Access Compliance Report

Public Rights-of-Way

(Curb Ramps)

Intersection ID: 5923	Main Street: FOREST_POND_DR	Cross Street: WILD_BERRY_CT	Location: SW
ADA ID: 8AA556D2065E	Ramp Type: Perp	Initial Pass/Fail: Fail	Overall Compliance: No
Severity Score: 22.5			
Codes/Mitigation Info/Possible Solution		Field Measurements/Component Compliance

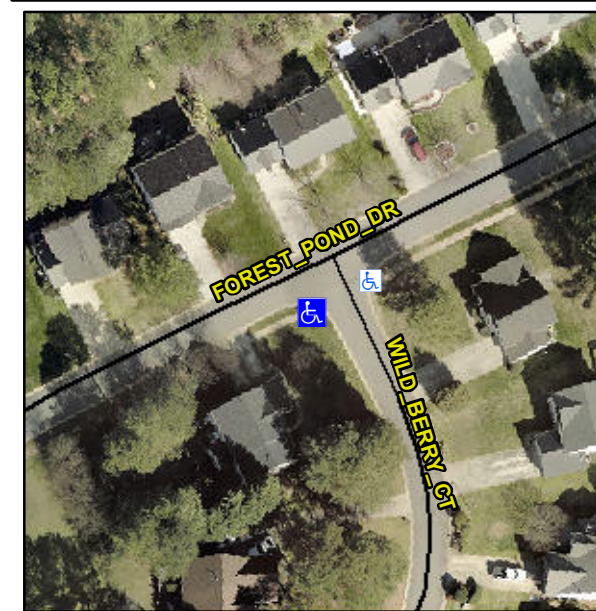
Not Found, R304.5.1, R304.2.2, R304.5.3

Compliance	Description	Data	Compliance	Description	Data
N/A	Ramp Length (in)	96.0	No	Ramp Slope (%)	9.2
No	Ramp Width (in)	44.5	No	Ramp XSlope (%)	4.7
N/A	Flare Type LT	N/A	N/A	Flare Type RT	N/A
N/A	Flare Slope LT (%)	N/A	N/A	Flare Slope RT (%)	N/A
N/A	Flare Traversable LT?	N/A	N/A	Flare Traversable RT?	N/A
N/A	Landing Length (in)	N/A	N/A	DWS Provided?	N/A
N/A	Landing Width (in)	N/A	N/A	DWS Contrast?	N/A
N/A	Landing Slope (%)	N/A	N/A	DWS Length (in)	N/A
N/A	Landing X Slope (%)	N/A	N/A	DWS Full Width?	N/A
N/A	Landing Curb? (Y/N)	N/A	N/A	DWS Offset (in)	N/A
N/A	Shared Landing?	N/A			
N/A	Gutter Ponding?	N/A	N/A	Gutter Slope (%)	N/A
N/A	Gutter Lip Ht (in)	N/A	N/A	Gutter X Slope (%)	N/A
N/A	Painted X Walk1?	No	N/A	Painted X Walk2?	N/A
	X Walk 1 Direction	To E		X Walk 2 Direction	N/A
N/A	X Walk 1 Width (in)	N/A	N/A	X Walk 2 Width (in)	N/A
	X Walk 1 Slope (%)	0.3		X Walk 2 Slope (%)	N/A
	X Walk 1 X Slope (%)	3.5		X Walk 2 X Slope (%)	N/A

Remove & Replace Entire Ramp.
